**BMP NUMBER: PC130**

# Stormwater Division

Upper wet pond located on the north side of the main entrance road; Combined folder with PC033

**MASTER GRADING, DRAINAGE &  
EROSION SEDIMENT CONTROL PLAN**  
FOR THE CLUSTER DEVELOPMENT  
**LONGHILL GATE**

**Photo 21 – Recreation Area**  
Standing water between the tennis courts and pool. Swa should be regraded to provide positive drainage and seeded.

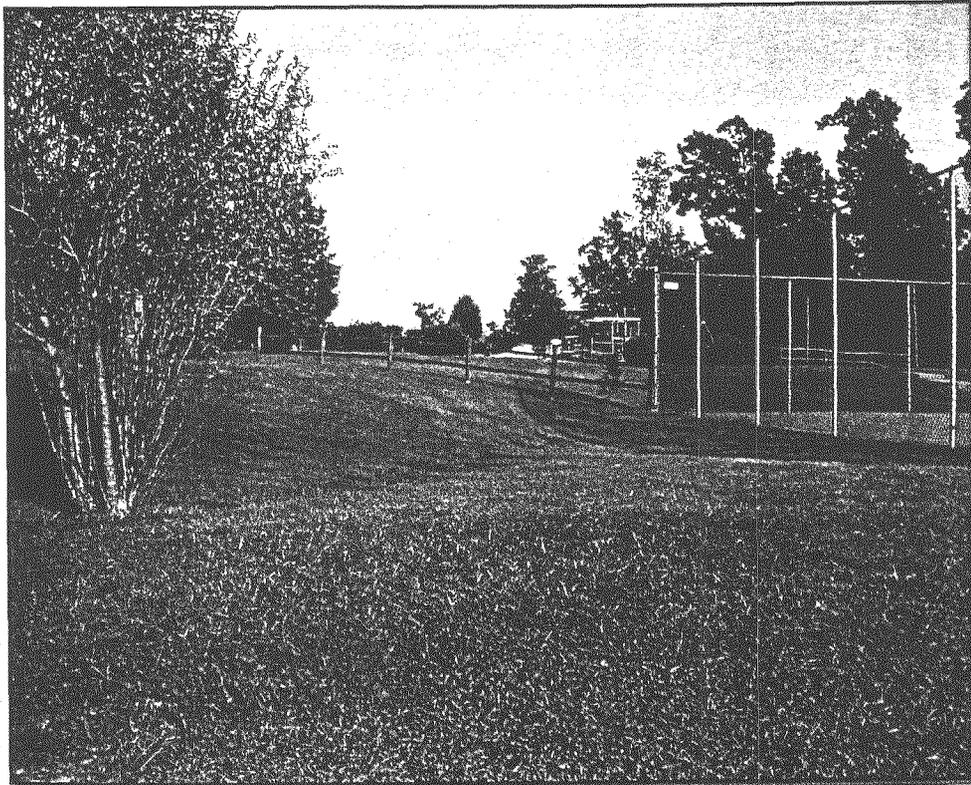
When inspecting the recreation area, an area between the tennis courts and the pool was evidenced to be poorly graded, with standing water. (See Photo 21) This area should be regraded to provide positive drainage towards the pond. After grading and shaping the area should be seeded and a mature stand of grass maintained.

**Photo 22 – Recreation Area**

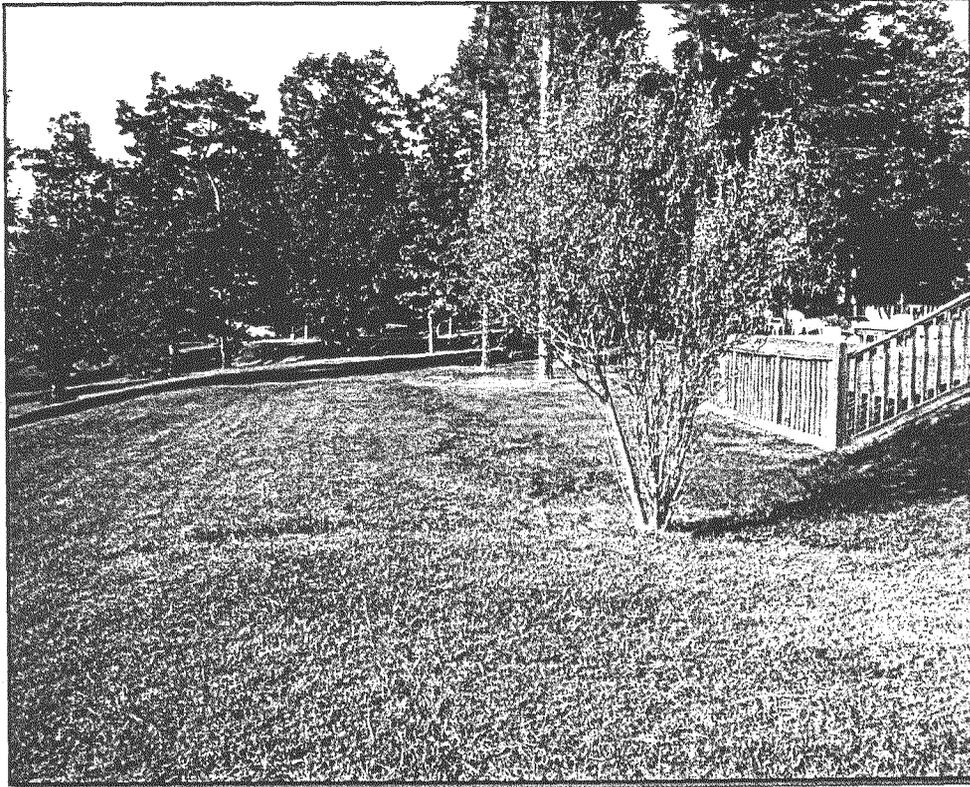
Another area of concern is located nearby between the pool and the pond. (See Photo 22) This area should also be repaired in a similar manner as the above-mentioned area.

Evidence of standing water behind the pool. Area should be regraded to provide positive drainage and seeded.
